**2009 Compliance Recertification Application (2009 CRA)
Compliance Application Review Documents (CARD) 194.14 and 194.15
Content of Compliance Certification Application
Content of Compliance Recertification Application(s)**

Figure 15-2. The WIPP Site is to the East of Nash Draw and Topographically Higher Than Nash Draw. Response to Precipitation Events at Surprise Springs Reflect Flow in Nash Draw, but not at the WIPP Site, Which is Over 8 Miles From the Land Withdrawal Boundary.

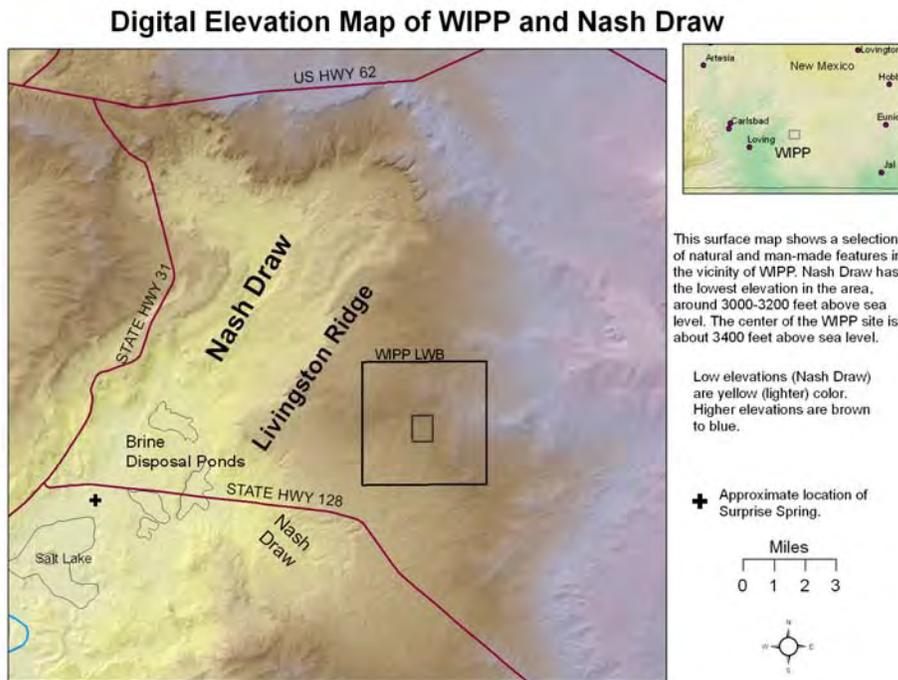
Because EPA's release requirements apply to the site, our primary interest is what happens at the WIPP site, that is, within the land withdrawal boundary (LWB), because the LWB defines the accessible environment. However, to get a better understanding of the WIPP site, it is useful to look at the area around the WIPP site. The land surface at the WIPP site generally slopes to the south and southwest. There is a topographic high, Livingston Ridge, northwest of the site, which is adjacent to Nash Draw, a topographic depression, further west (Figure 15-2).

Our understanding of the disposal system indicates that the WIPP site characteristics are distinct from Nash Draw such that extrapolations of karst in Nash Draw have little bearing on the WIPP site. Recharge characteristics and resulting discharge are one example of misrepresentation of the data by commenters. Precipitation events that occur in Nash Draw affect Nash Draw but appear to be independent of the WIPP site (See Section 15.2.4 below for new information in the 2009 CRA). The use of Surprise Spring in Nash Draw (see Figure 15-2) as an indicator of karst at WIPP is inappropriate. Surprise Spring is over 8 miles from the WIPP LWB. With the northeast to southwest flow in Nash Draw and a water table that is near the surface, Surprise Spring discharges are only a result of precipitation events that affect Nash Draw. In contrast at the WIPP site, well head data shows no response to precipitation events.

Figure 15-3. 2004 CRA-Locations of Culebra well tests.

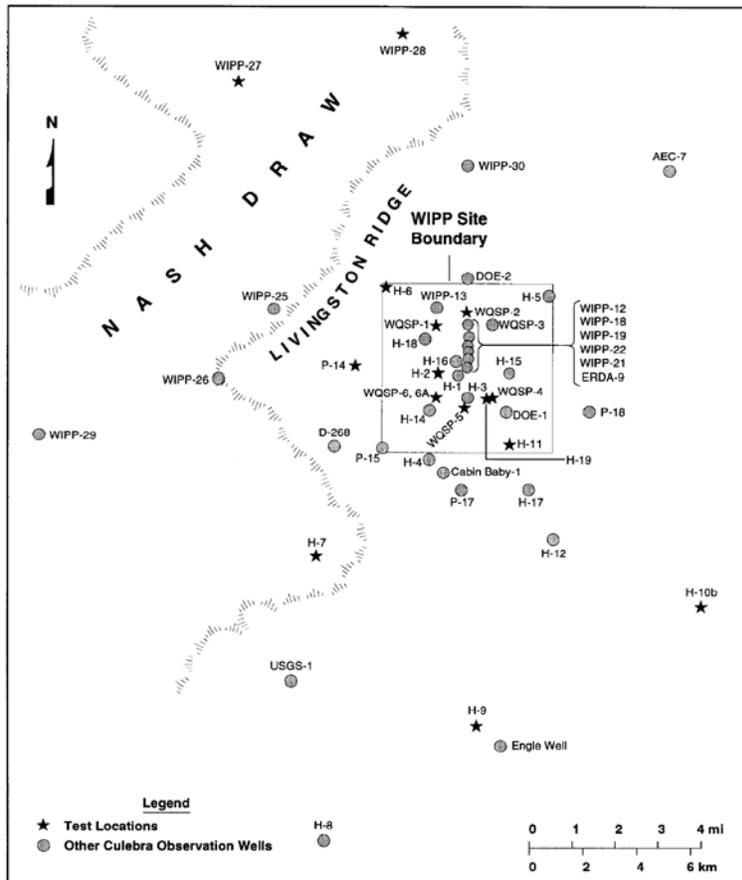
DOE has studied the WIPP site and vicinity for over thirty years (see Figure 15-3 for locations of Culebra well tests). New data is collected annually. In addition to the geologic studies, numerous pump test tests have been done, including large scale pumping tests (e.g., Beauheim and Ruskauff, 1998) and other analyses. DOE has provided these data and analysis results in the 2004 CRA and other reports. These data and their analyses provide information over large areas and form the basis for the performance assessment modeling and much of the discussion presented here. For example, in the 2004 CRA, DOE identified that the Culebra transmissivity is a function of overburden thickness—the deeper the Culebra, the lower the transmissivity (2004 CRA Appendix PA, Attachment TFIELD). Superimposed on the depth are geologic factors such as the location relative to the margin of upper Salado dissolution and to halite in the M3/H3 interval of the Tamarisk.

Figure 15-4. 2004 CRA-Four Hydrochemical Facies in the Culebra Siegel et al. 1991

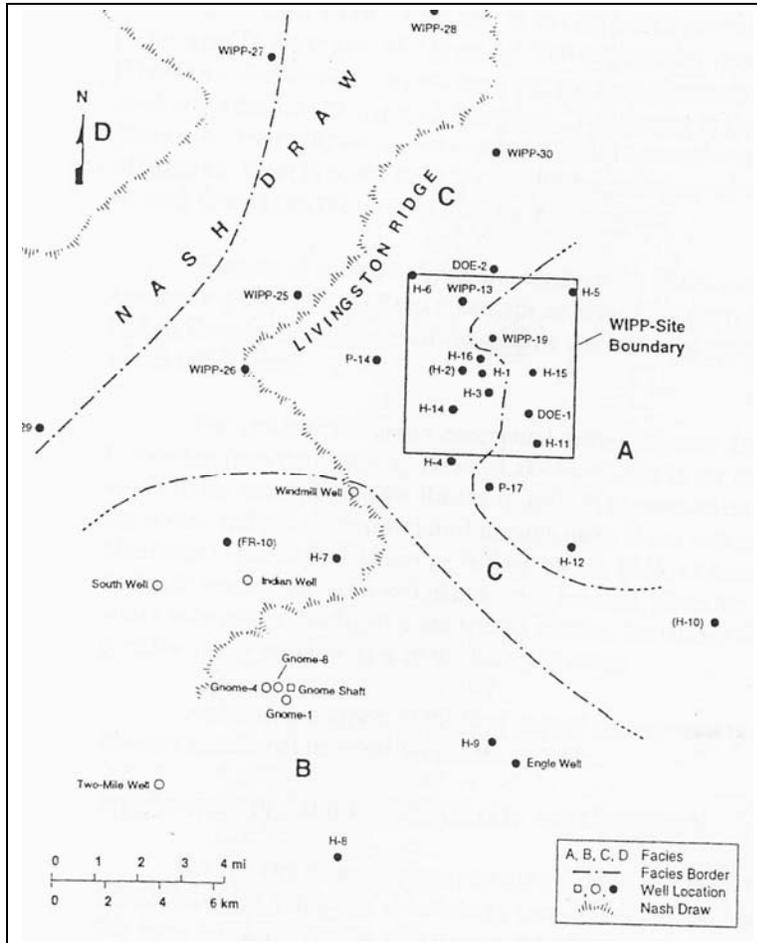
EPA believes that, on a regional scale, the groundwater basin model done by DOE reasonably predicts the current ground water flow regime and the geochemistry of the site.

Figure 15-6 2009 CRA-Culebra Tests Wells

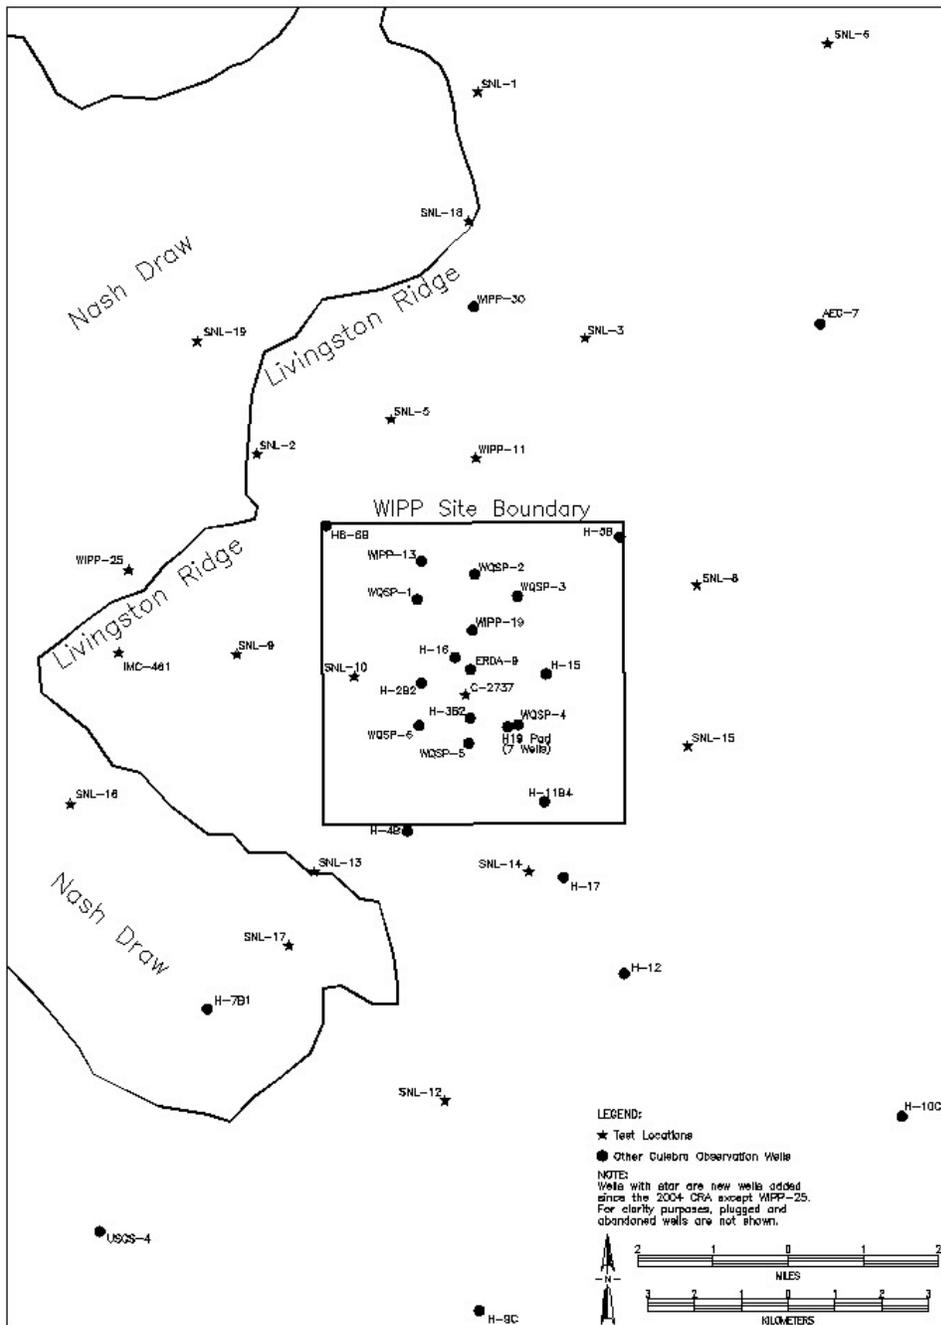
The new conceptual model uses information gained from the new monitoring wells drilled and tested (Burgess et al. 2008, Figure 15-6 of this CARD) since the 2004 CRA. The original CCA conceptual model peer review panel found that the CHCM failed to correlate the detailed hydrogeology of the Culebra with its tested hydrologic character but that adequate data existed from hydraulic testing to develop a numerical model for PA. In particular, the new well data has allowed DOE to modify the implementation of this conceptual model. As noted on Page 1 of Burgess et al. 2008 of the revised conceptual model; "...the hydraulic properties of the Culebra are related to geologic features and processes. By correlating the measured hydraulic properties at individual well locations to the geologic conditions at those locations, a basis can be developed for assigning hydraulic properties at untested locations where the geologic properties are known." Inclusion of recent well data into the new conceptual model allowed DOE to develop transmissivity fields that are geologically based, consistent with observed groundwater heads, consistent with groundwater responses in Culebra pump test, and consistent with water chemistry (Burgess et al. 2008, page 3).
